**Date of Issue:** July 2003

**Affected Publication:** API Standard 612, *Petroleum, Petrochemical and Natural Gas Industries—Steam Turbines—Special-purpose Applications*, Fifth Edition, April 2003

## ERRATA

Figure 4 — Turbine ramp speeds

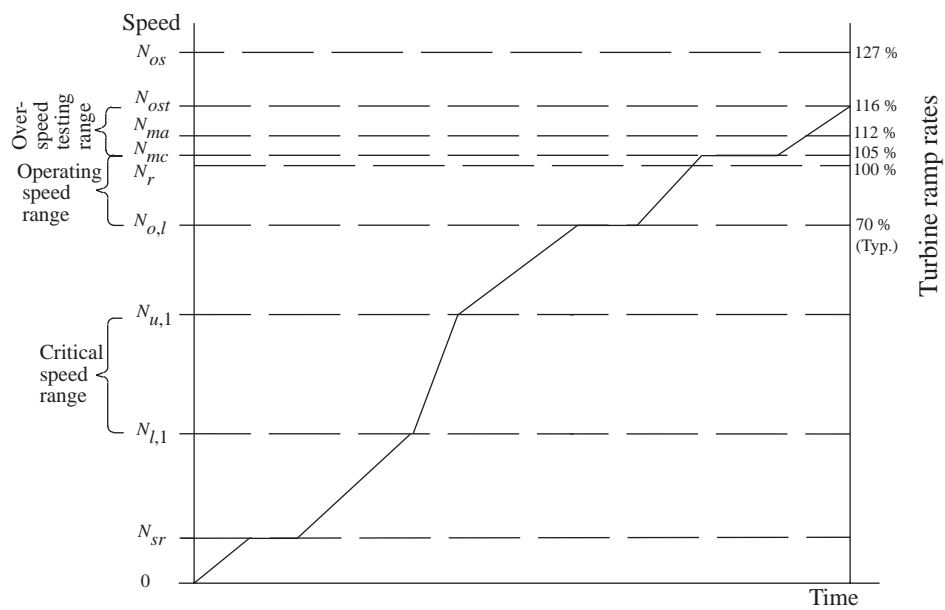
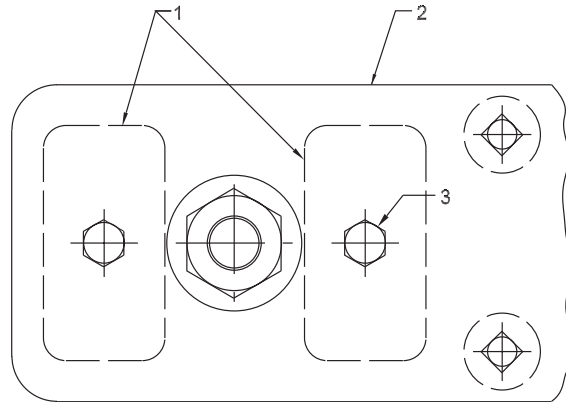
Page 38, replace Figure 4 with the following:

Figure F.1 — Typical mounting plate arrangement — Soleplate with subplate

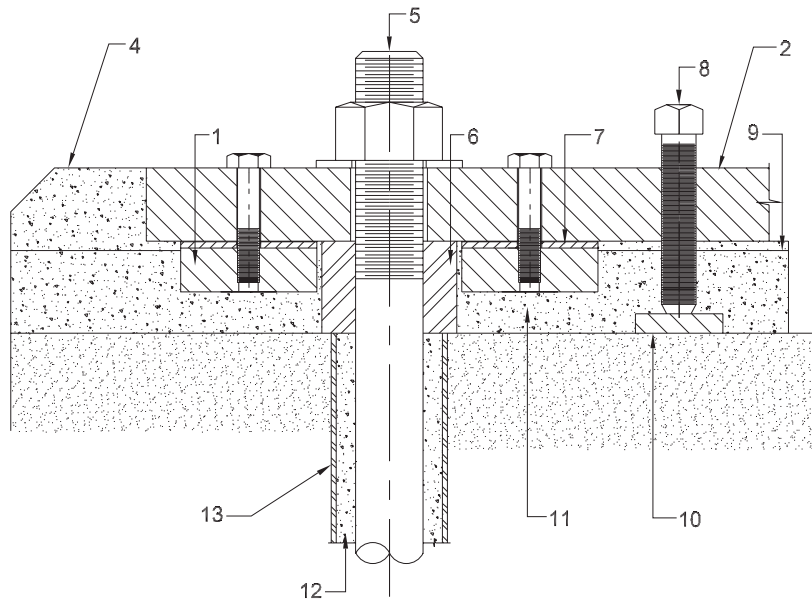
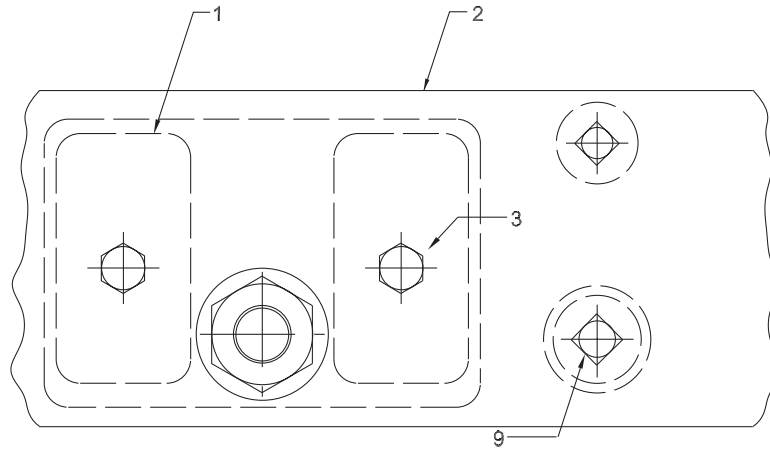
Page 97, replace Figure F.1 with the following:

Figure F.2 — Typical mounting plate arrangement — Baseplate with subplate

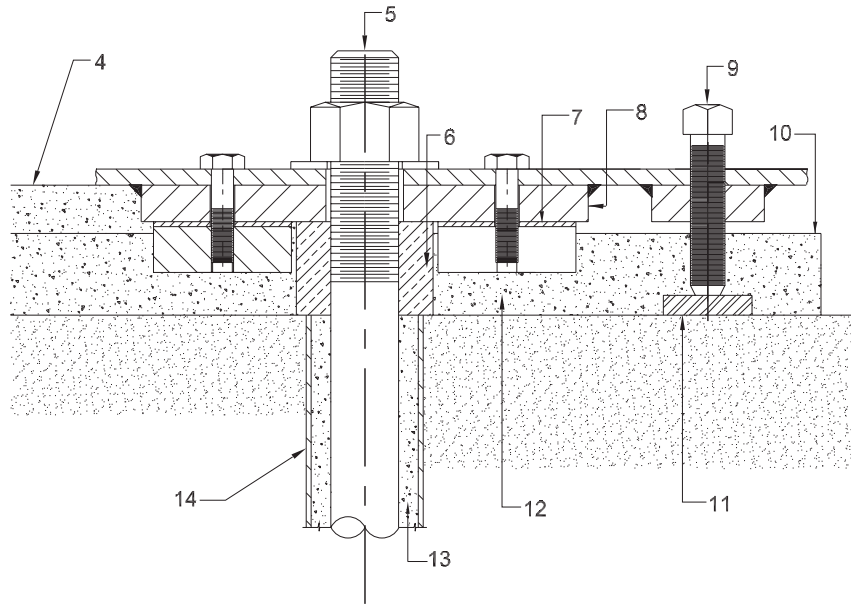
Page 98, replace Figure F.2 with the following:

Figure G.1 — Typical gland sealing and leak-off system for condensing turbines

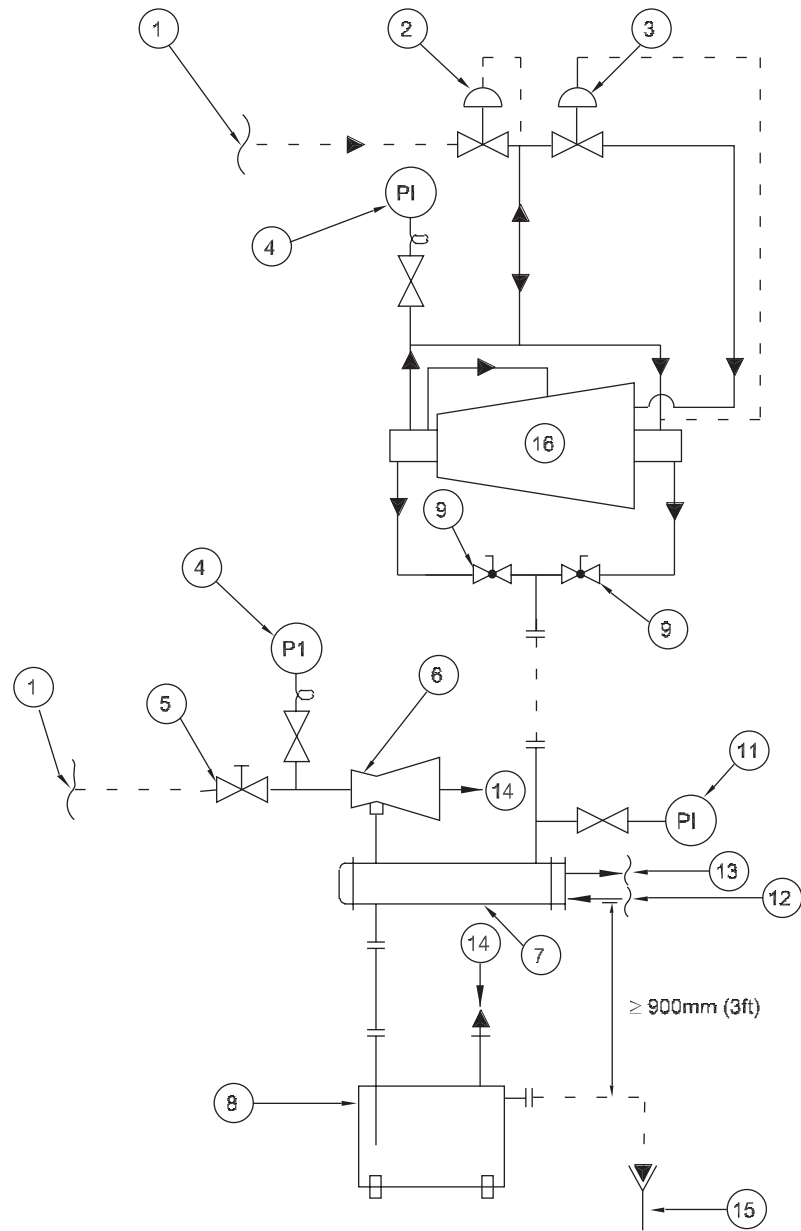
Page 101, replace Figure G.1 with the following:

Figure G.2 — Typical gland leak-off system for back-pressure turbines

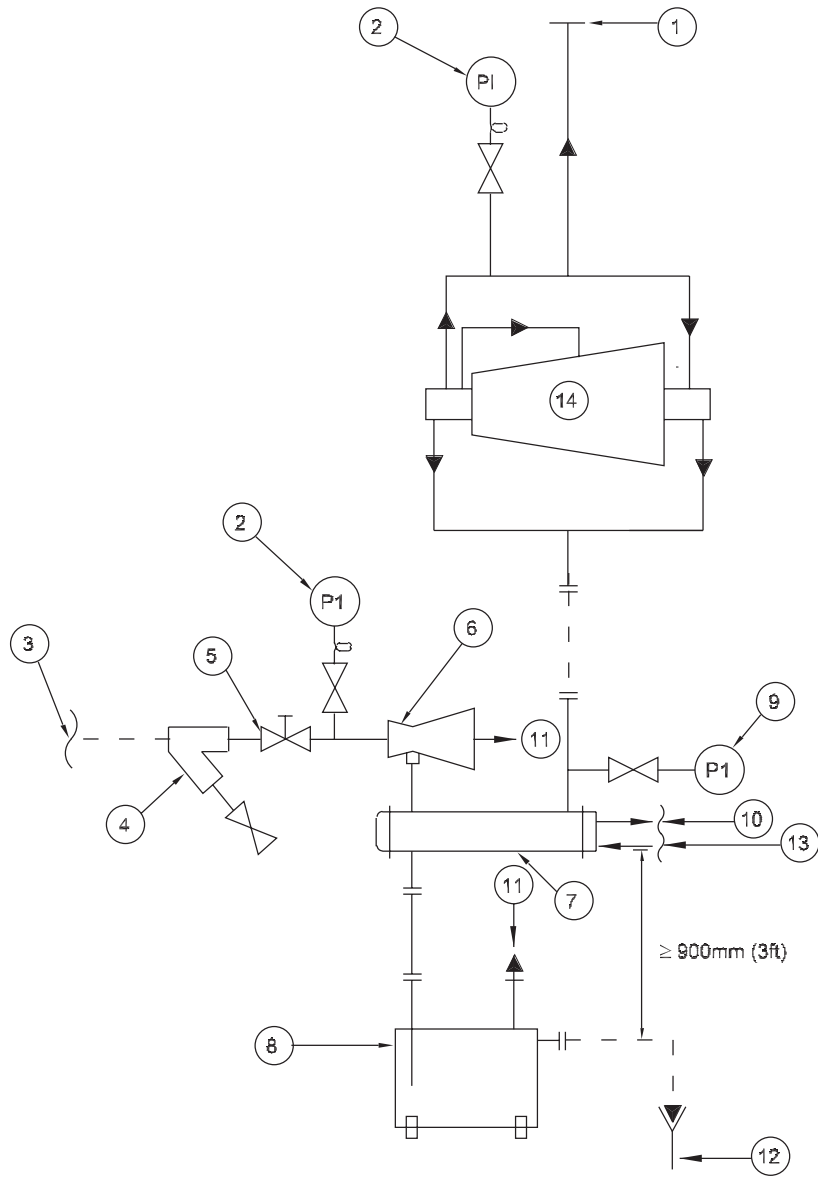
Page 102, replace Figure G.2 with the following:
